Morganton, NC
Force Main
Erosion Control

FINAL DESIGN - 100%
RELEASED FOR
CONSTRUCTION

DATE: 05/04/23
SHEET **CE2.3**

Bost Rd Sewer Improveme
Morganton, NC
Force Main
Erosion Control

SHEET **CE2.4**

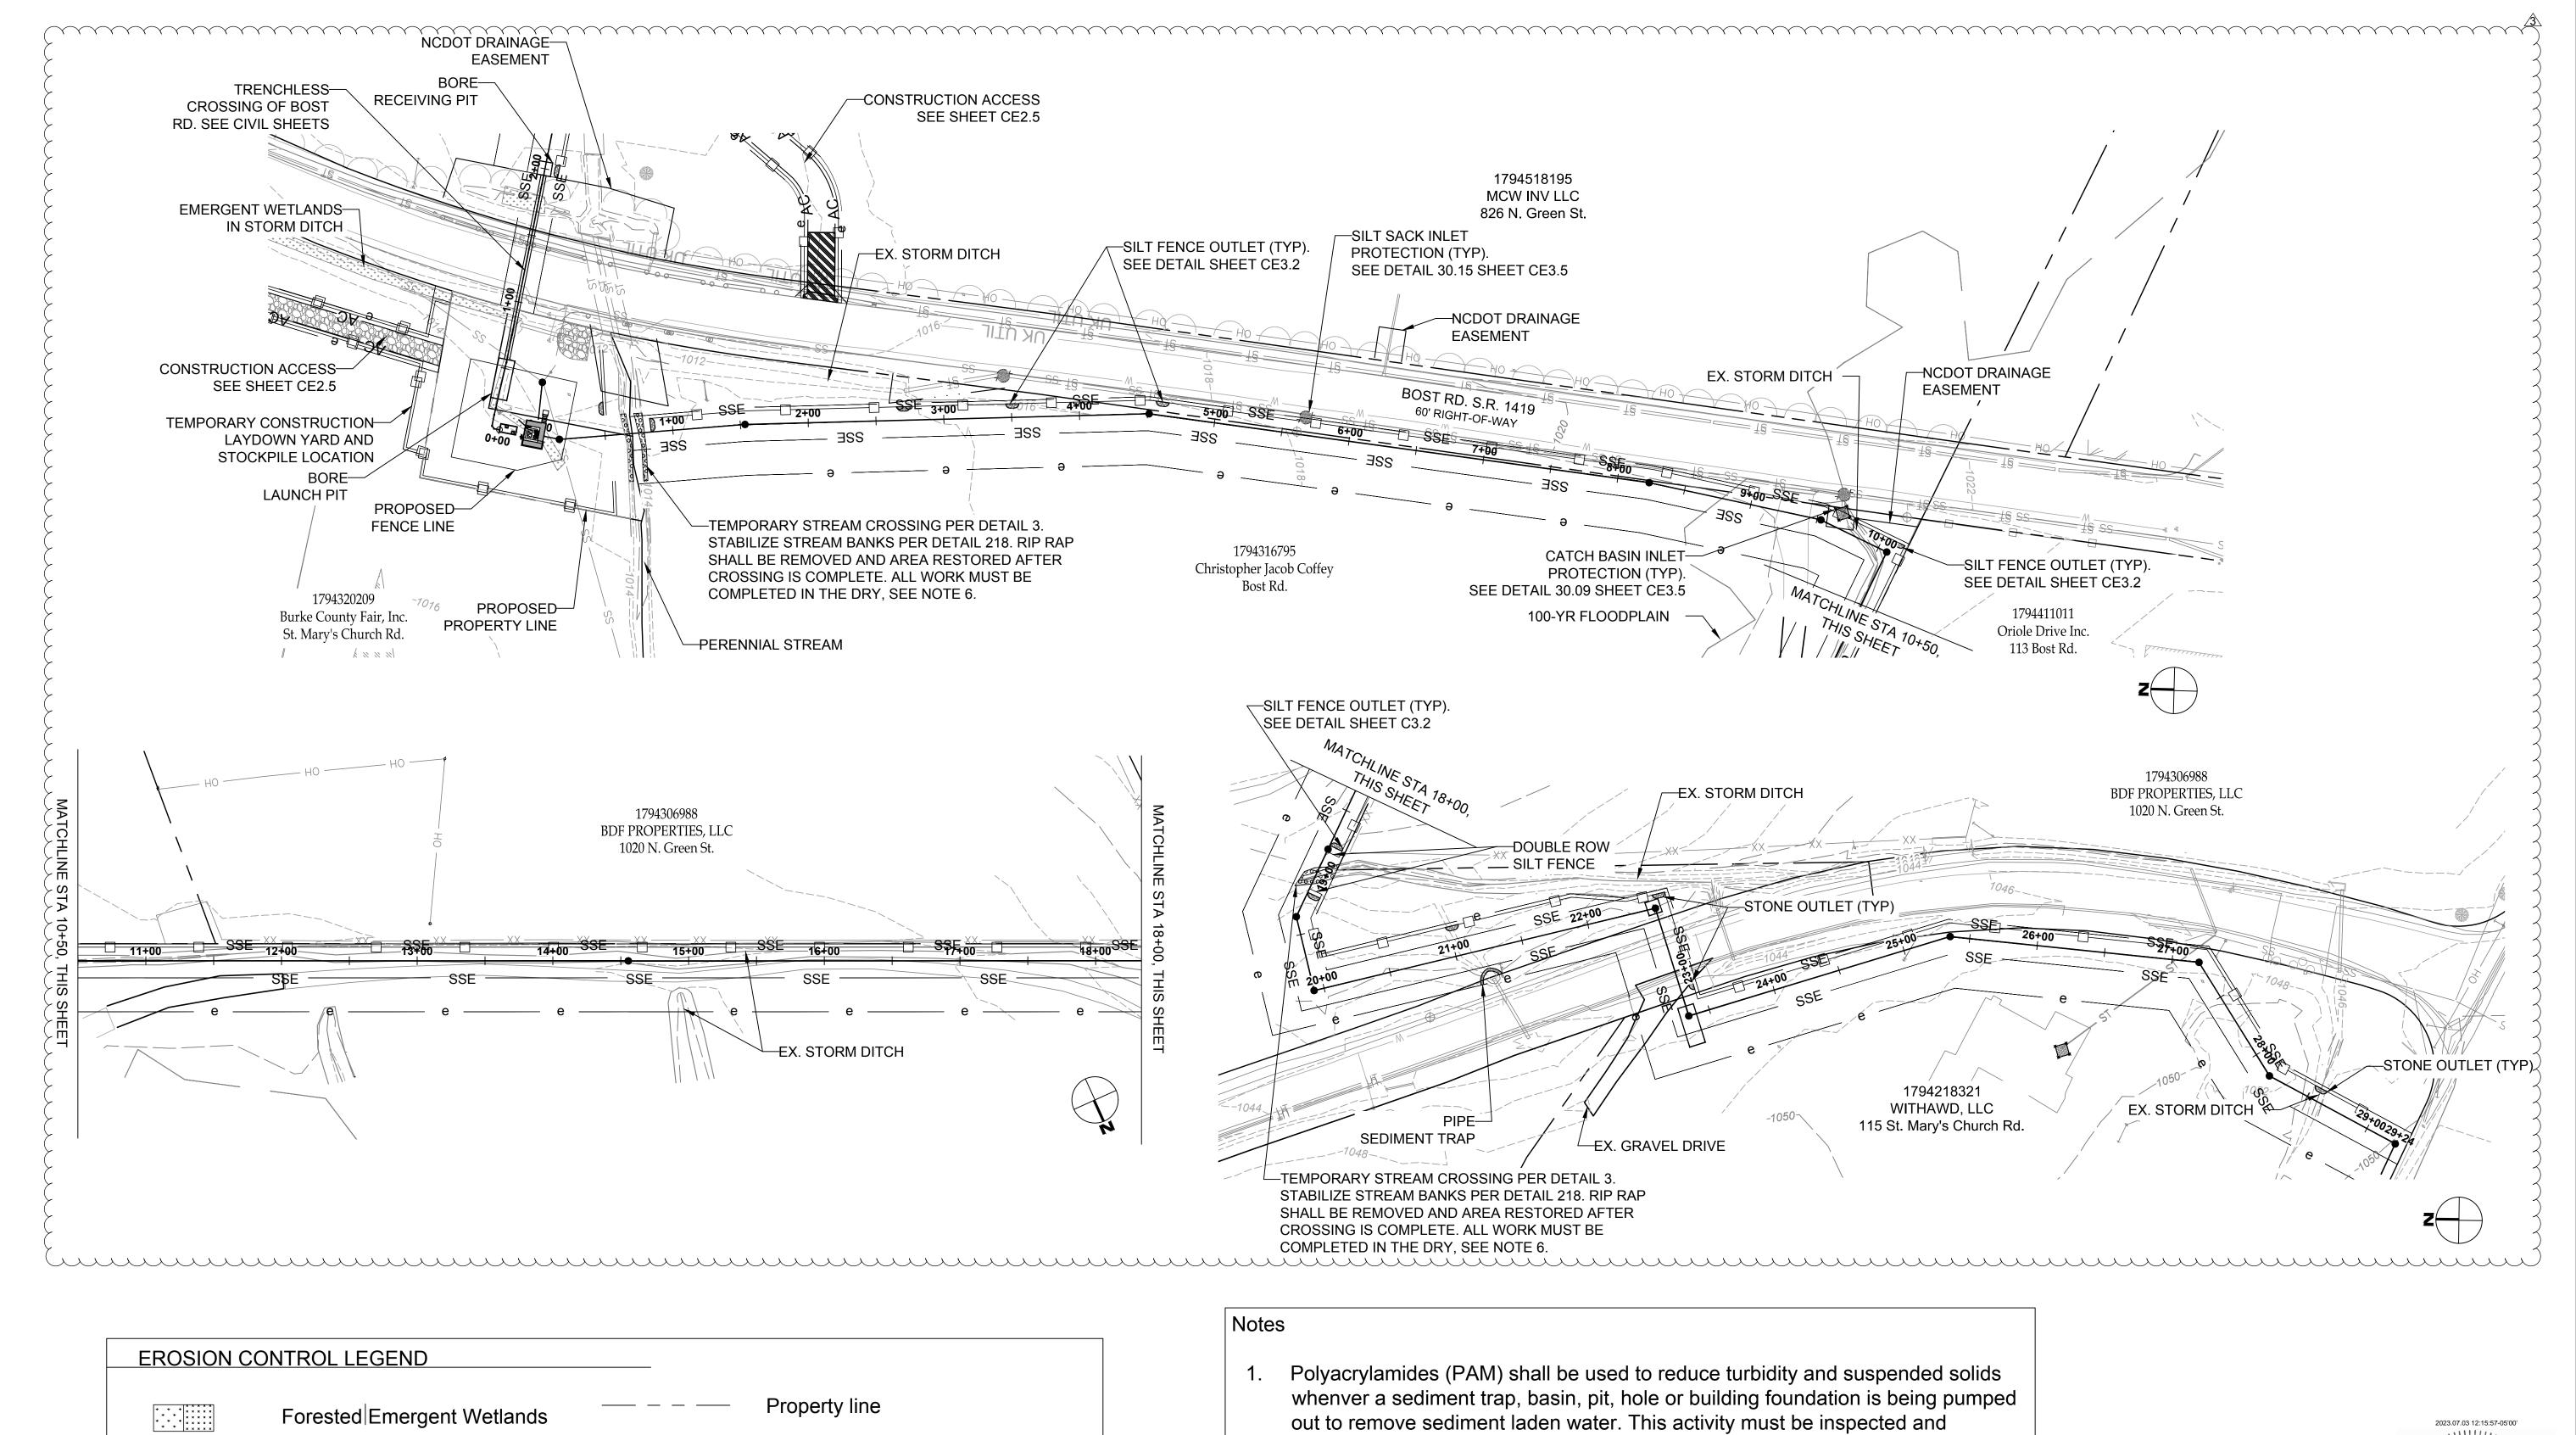
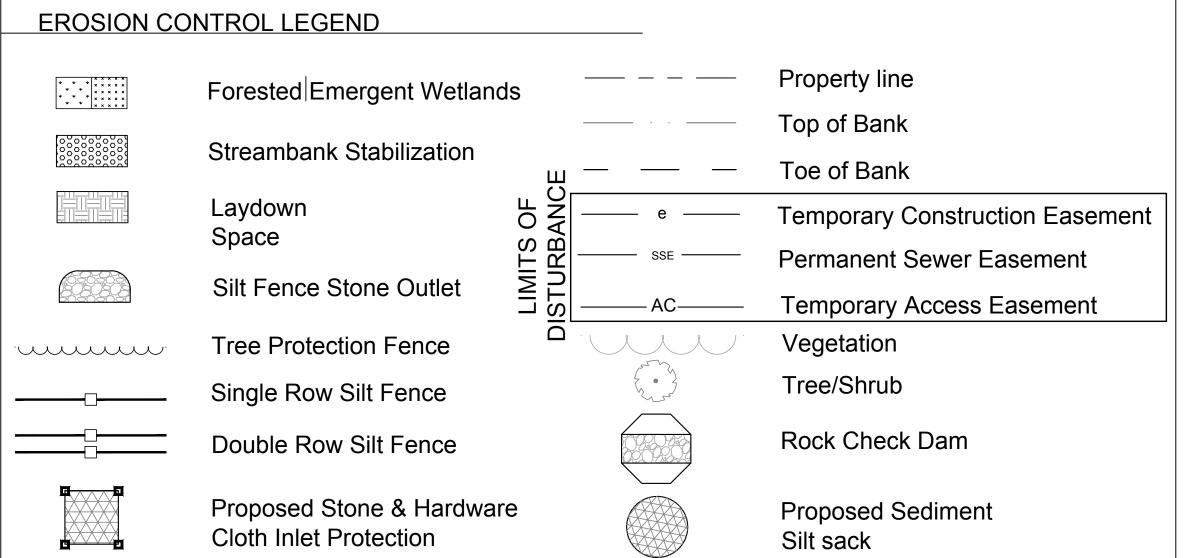
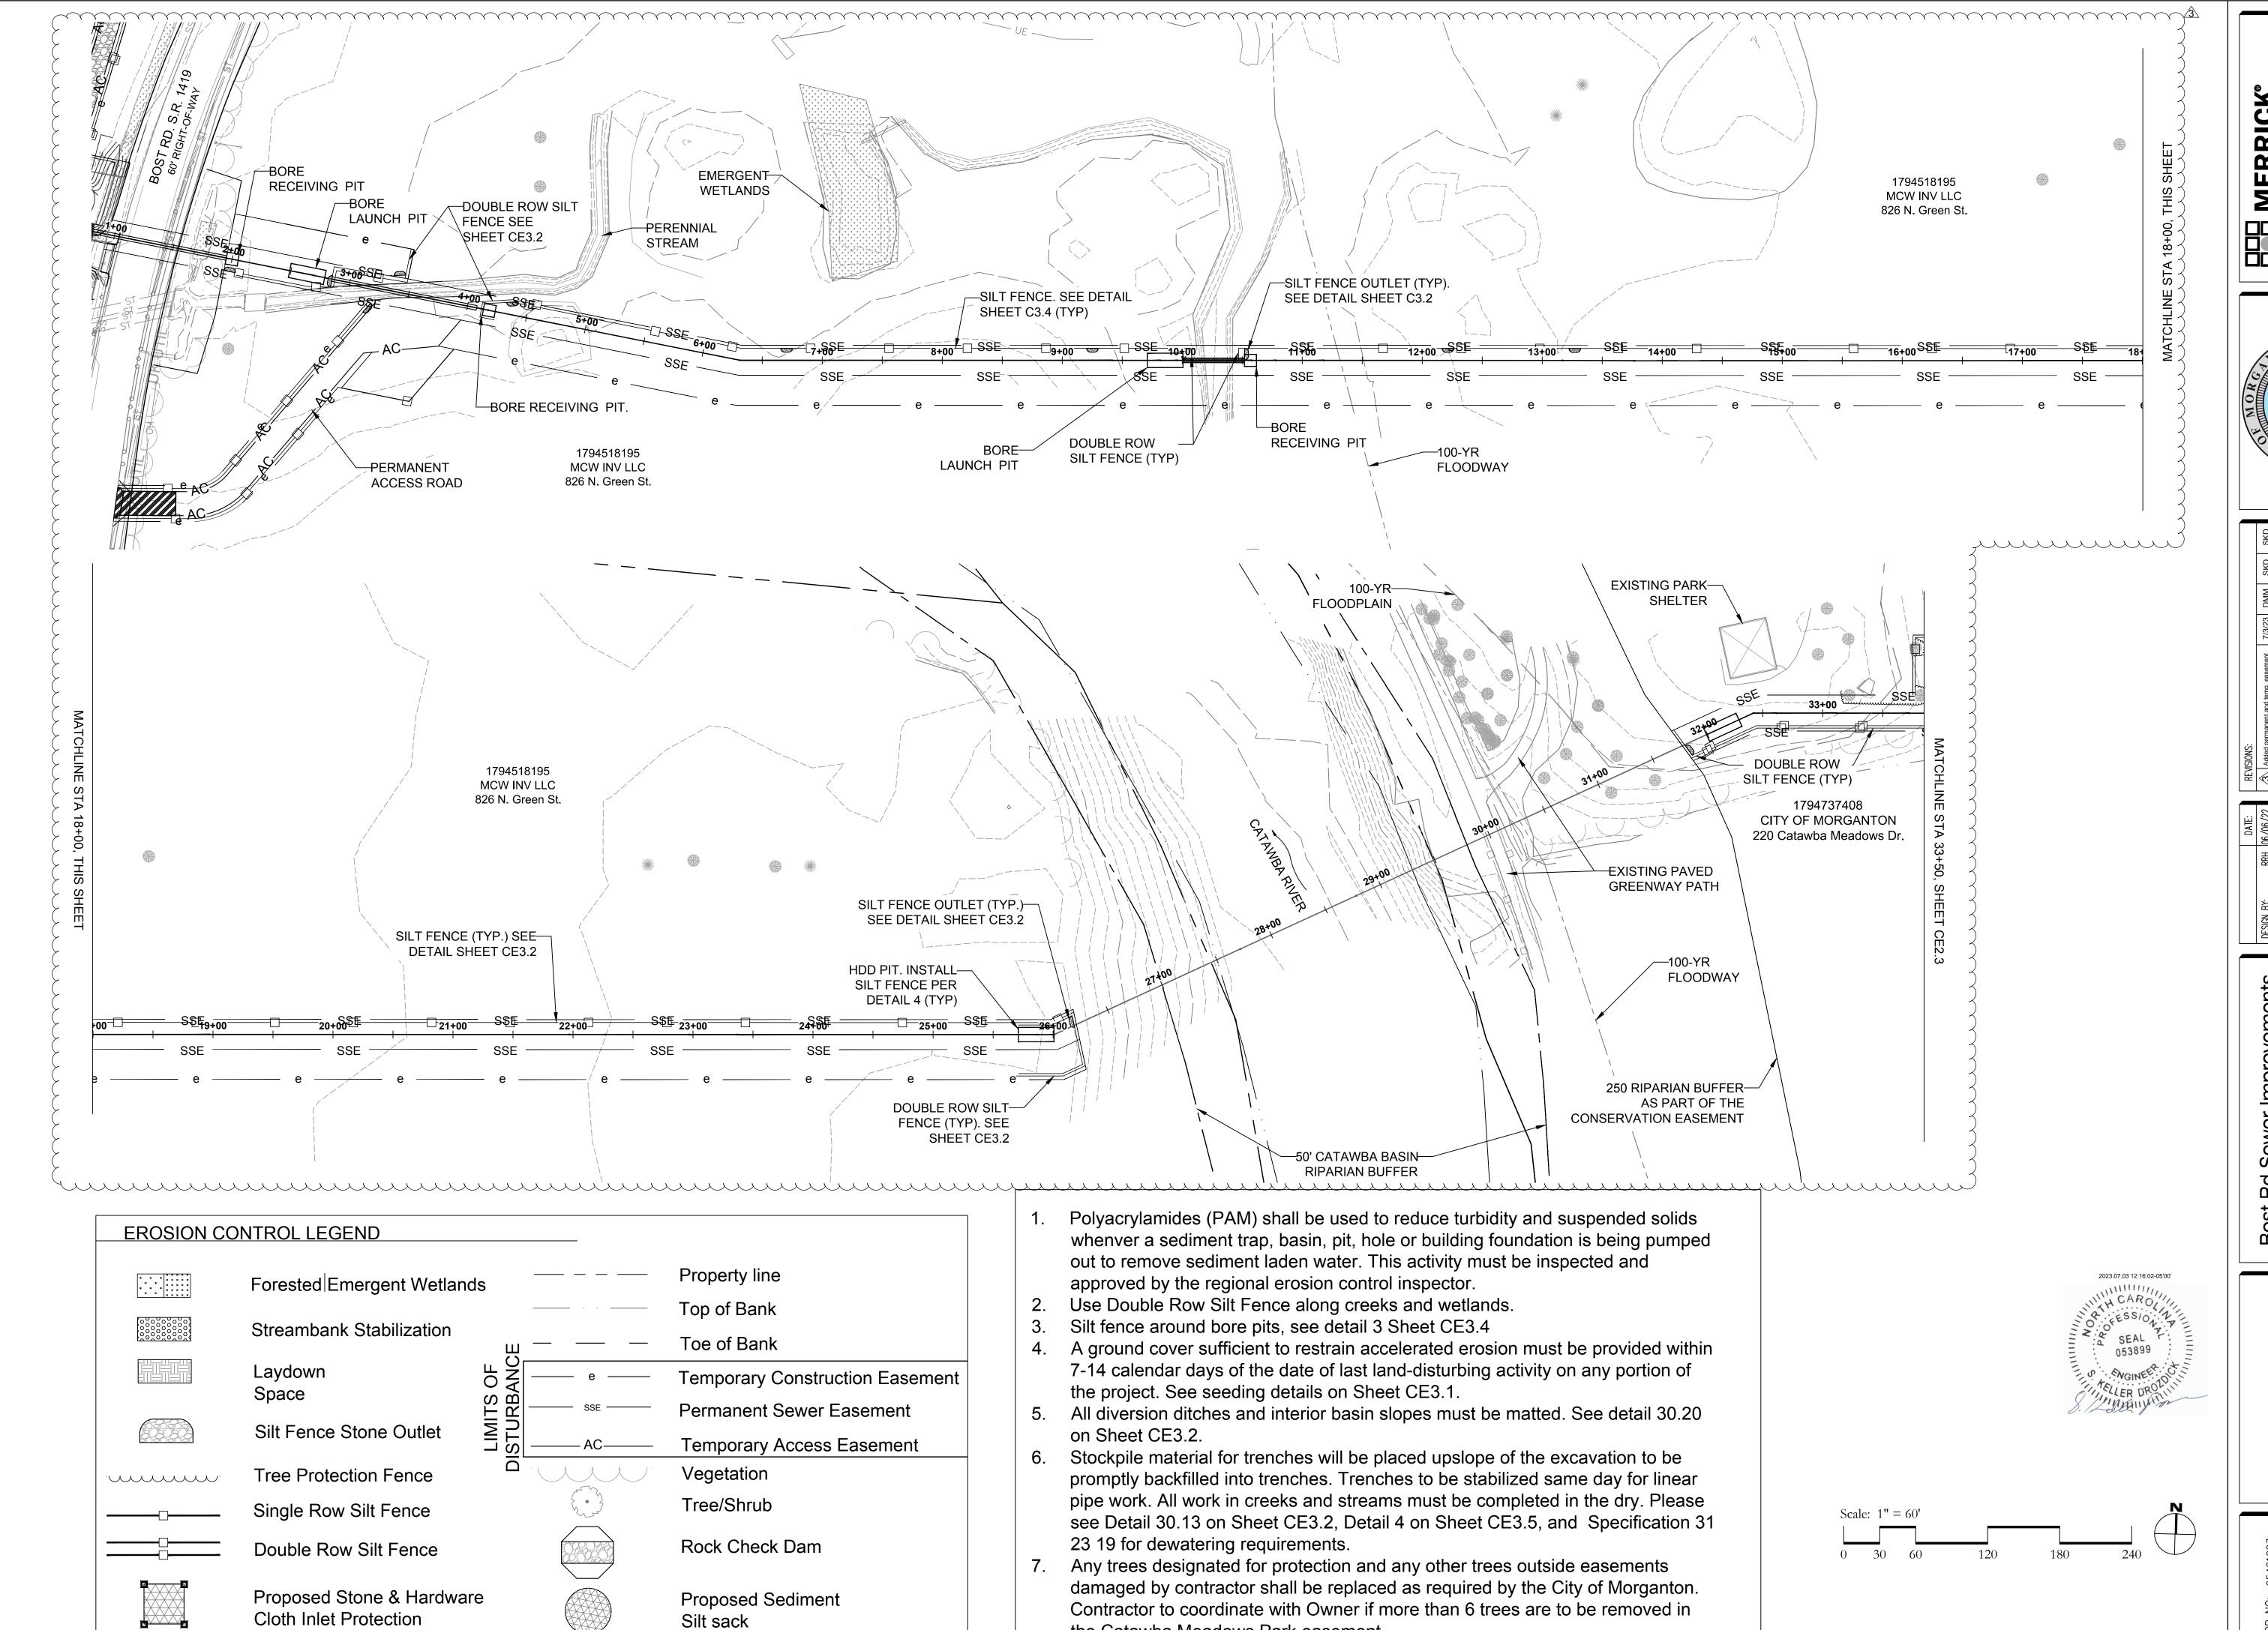
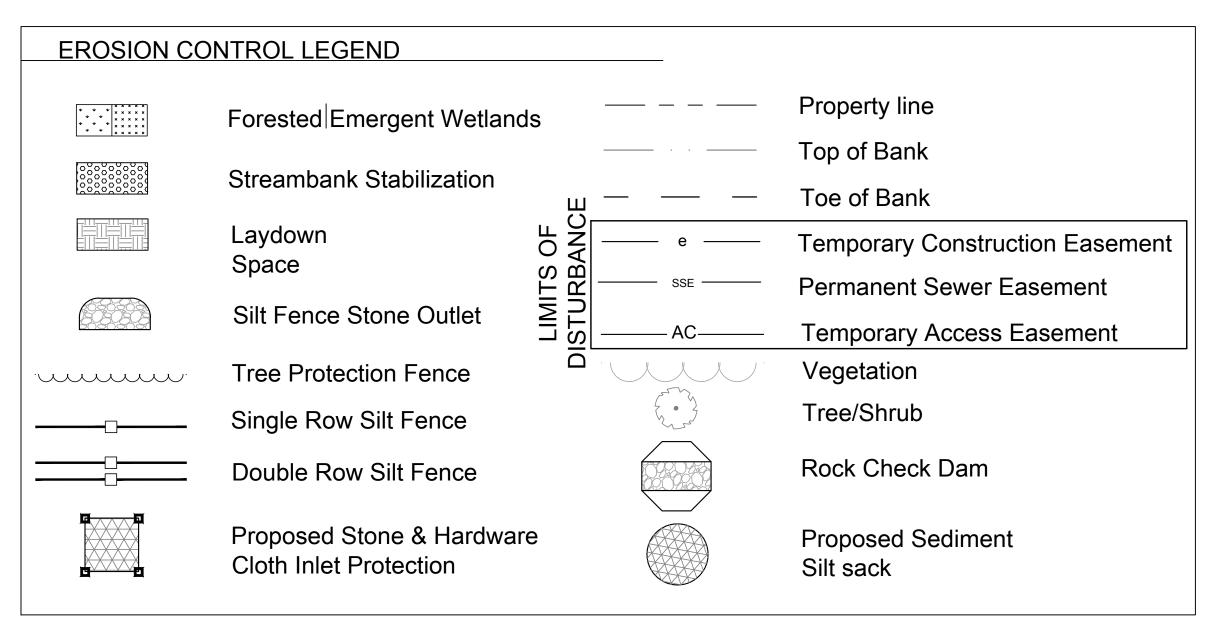
REV	REVISIONS:				
⊗	$ 3\rangle$ Added permanent and temp. easement	7/3/23 DMM	DMM	SKD	SKD
EV	REV REVISION DESCRIPTION	DATE:	CHANGED BY:	CHANGED CHECKED APPROVED BY: BY:	Approved By:
